APPLICATION FOR IMPROVEMENT PERMIT FOR RESIDENTIAL SITE INDIVIDUAL WATER AND WASTEWATER SYSTEMS PROGRAM

STREET ADDRESS: 12815 Allison Ferry Rd

Permit Number: 1915B

SOIL/SITE EVALUATION
for ON-SITE WASTEWATER SYSTEM

PROPOSED PLOT PLAN

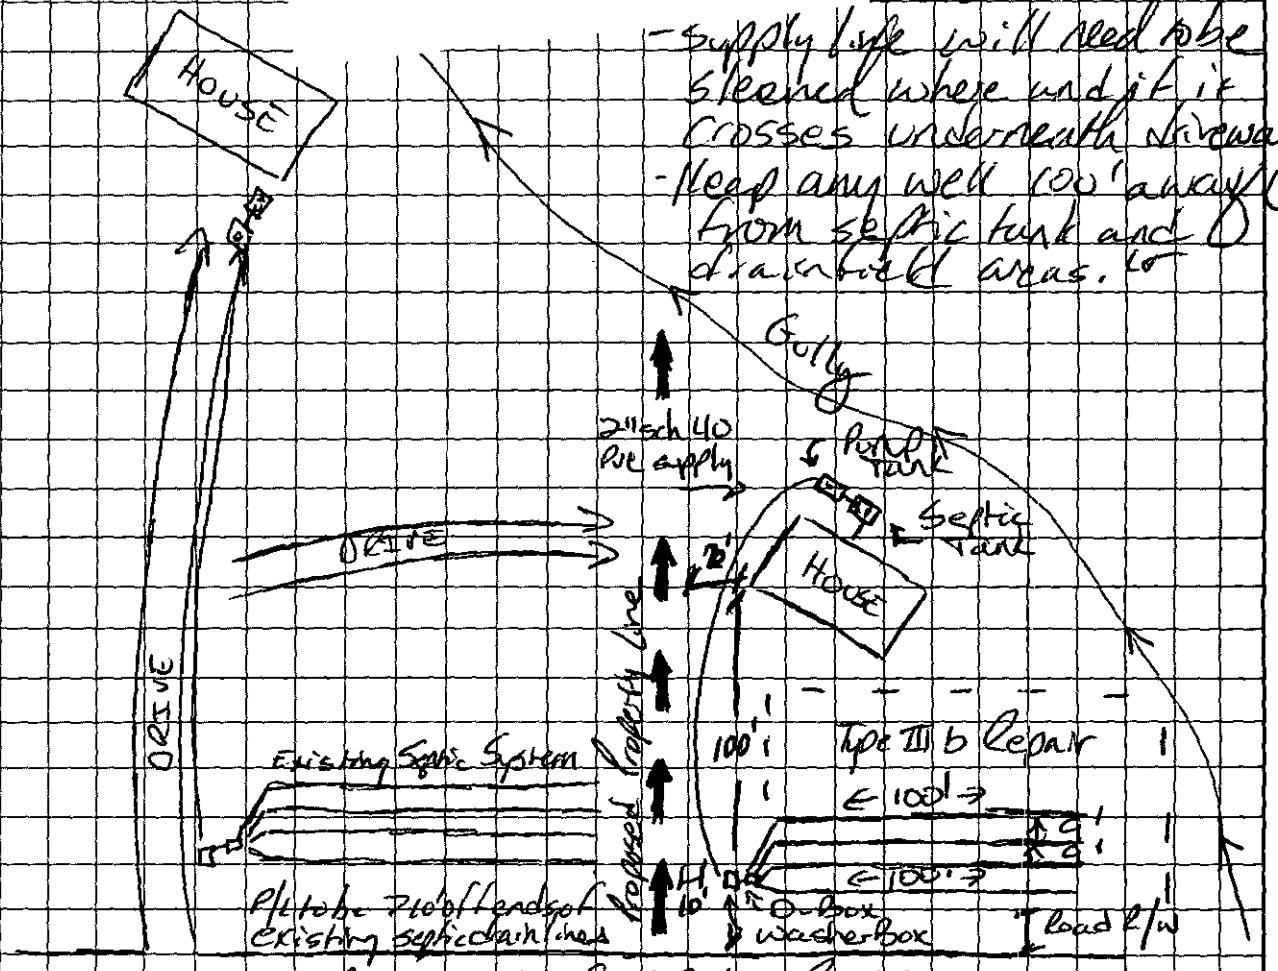
Need:

- Signature on Plot Plan
- Cond. of I.P.
- Const. Authorization

COMMENTS
on Septic Tank
on Pump Tank
2 D-Box Set-up
100'L x 12" stone
with depth 33"
with bottoms level
on bour

- Supply line will need to be sleeved where undisturbed it crosses underneath driveway.
- Keep any well 100' away from septic tank and drainfield areas.

PROPOSED PLOT PLAN

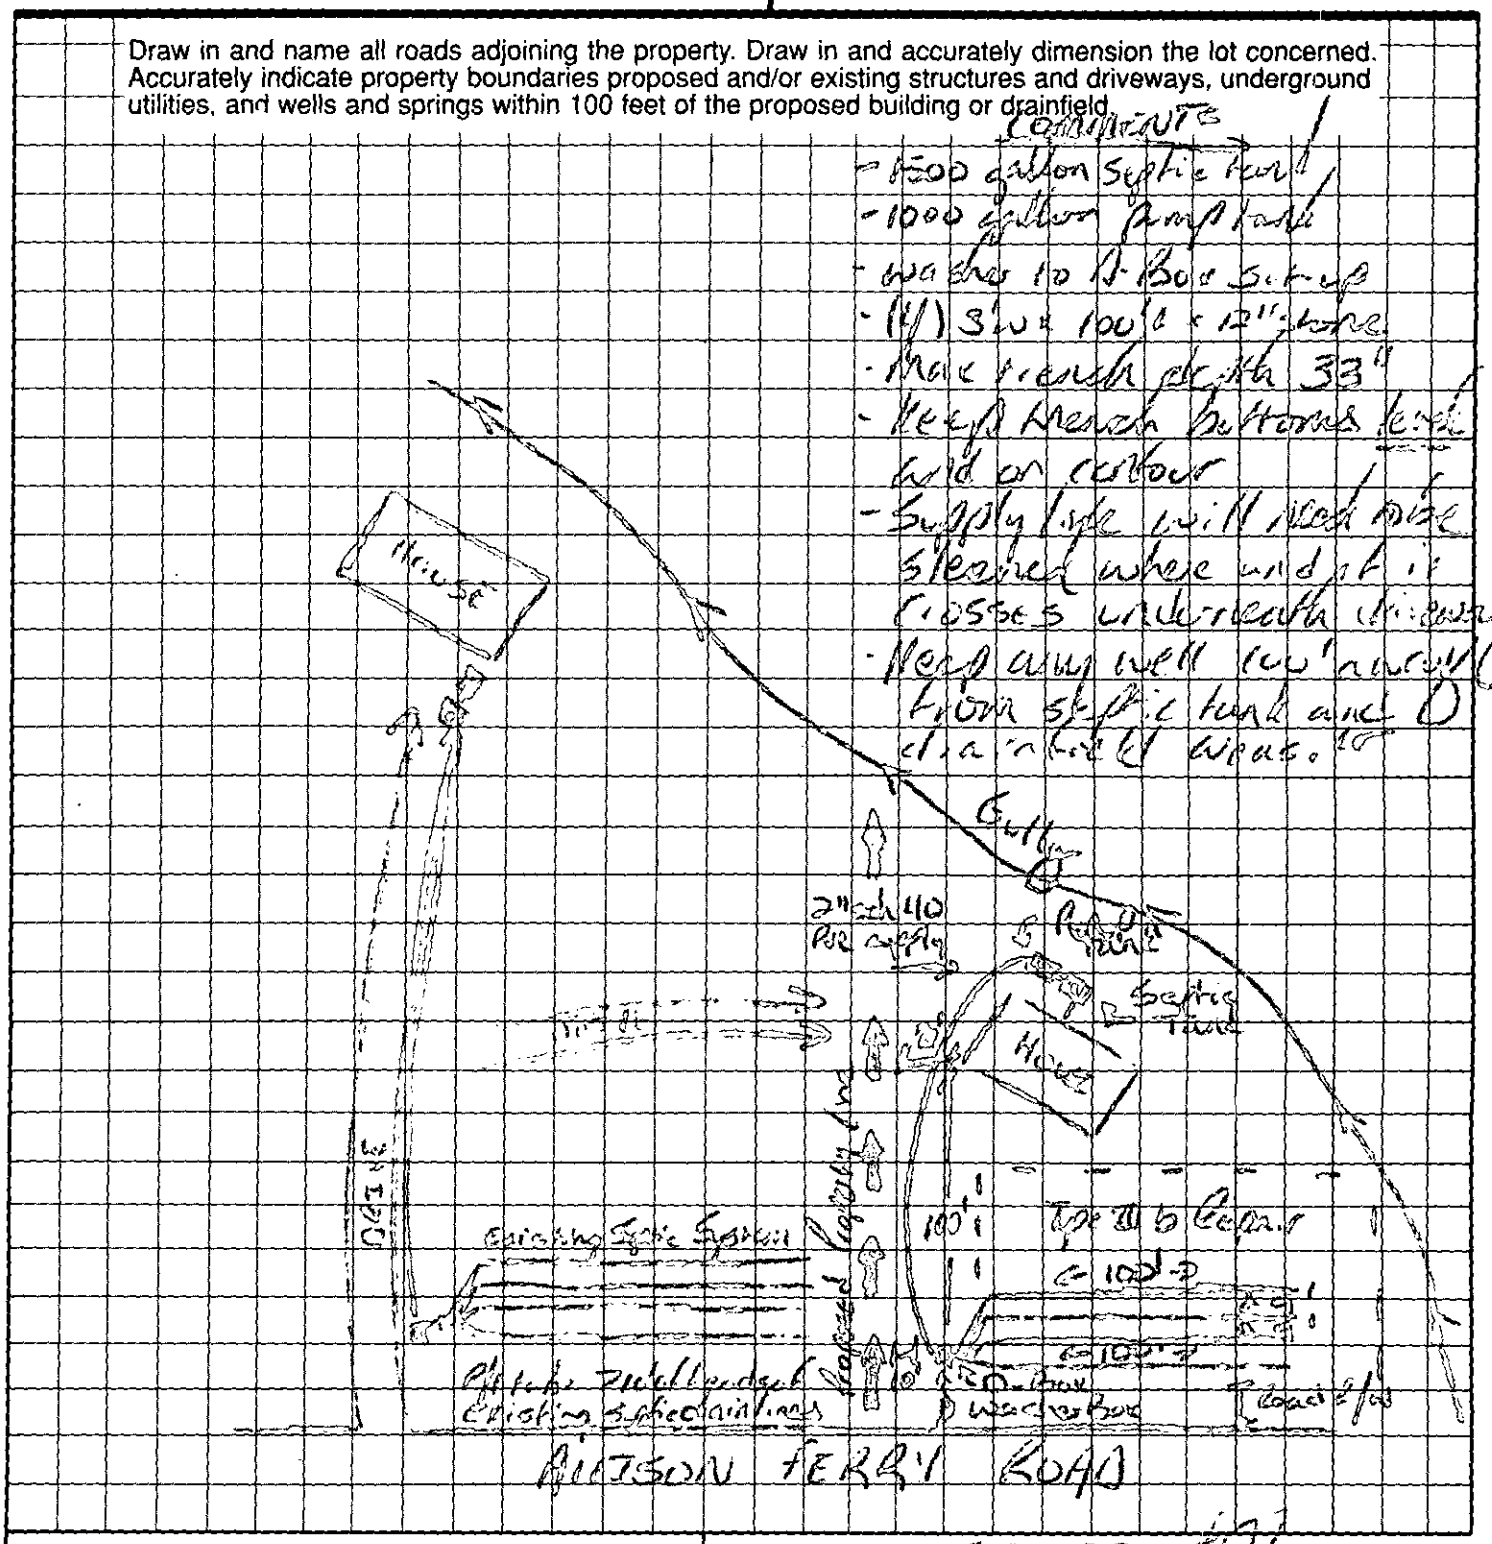
OMMENTS: 100% Repair - may have slight depression
5-28-97 House site adjusted to allow for more room
